Access Compliance Report

Public Rights-of-Way

Intersection ID: 10033070	Main Street: NORTH_COMMUNITY_HOUSE_RD	Cross Street: N/A	Location: NW
ADA ID: E0FE4A91E238	Ramp Type: BlendTrans1	Initial Pass/Fail: Pass	Overall Compliance: No
		Severity Score: 0

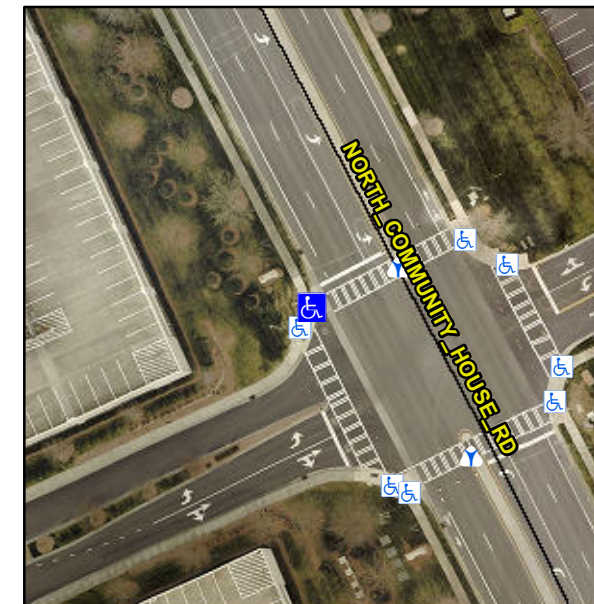
PROW/ADA:

Not Found, R304.2.1

Compliance	Description	Data	Compliance	Description	Data
N/A	Ramp Length (in)	24.0	Yes	BlendTrans Slope (%)	3.4
Yes	Ramp Width (in)	48.0	Yes	BlendTrans XSlope (%)	0.5
N/A	Flare Type LT	Sloped	N/A	Flare Type RT	Sloped
Yes	Flare Slope LT (%)	0.4	Yes	Flare Slope RT (%)	8.5
N/A	Flare Traversable LT?	Yes	N/A	Flare Traversable RT?	Yes
No	Landing Length (in)	51.0	Yes	DWS Provided?	Yes
No	Landing Width (in)	47.0	Yes	DWS Contrast?	Yes
Yes	Landing Slope (%)	1.8	Yes	DWS Length (in)	24.0
Yes	Landing X Slope (%)	0.7	Yes	DWS Full Width?	Yes
N/A	Landing Curb? (Y/N)	Yes	Yes	DWS Offset (in)	0.0
N/A	Shared Landing?	No			
Yes	Gutter Ponding?	No	Yes	Gutter Slope (%)	3.9
Yes	Gutter Lip Ht (in)	0.0	Yes	Gutter X Slope (%)	0.9
N/A	Painted X Walk1?	Yes	N/A	Painted X Walk2?	N/A
	X Walk 1 Direction	To NE		X Walk 2 Direction	N/A
	X Walk 1 Width (in)	110.5		X Walk 2 Width (in)	N/A
	X Walk 1 Slope (%)	3.3		X Walk 2 Slope (%)	N/A
	X Walk 1 X Slope (%)	1.8		X Walk 2 X Slope (%)	N/A

Yes	Ramp inside XWalk1?	Yes	N/A	Ramp inside XWalk2?	N/A
	Road Slope (%)	1.8		Clear Space?	Yes
	Road X Slope (%)	3.3	N/A	Clear Space to XWalk (in)	N/A
Yes	Any Obstructions?	No	Yes	Storm Grate/Utility Hazard?	No
	Obstruction Type			Storm Grate/Utility Type	
		N/A			N/A
			Yes	Surface Condition? (G/P)	Good
			No	Curb Slope (%)	20.8

Remove & Replace Curb Ramp With Two New Directional Ramps or Equivalent.

Total Cost: \$ 3200.00
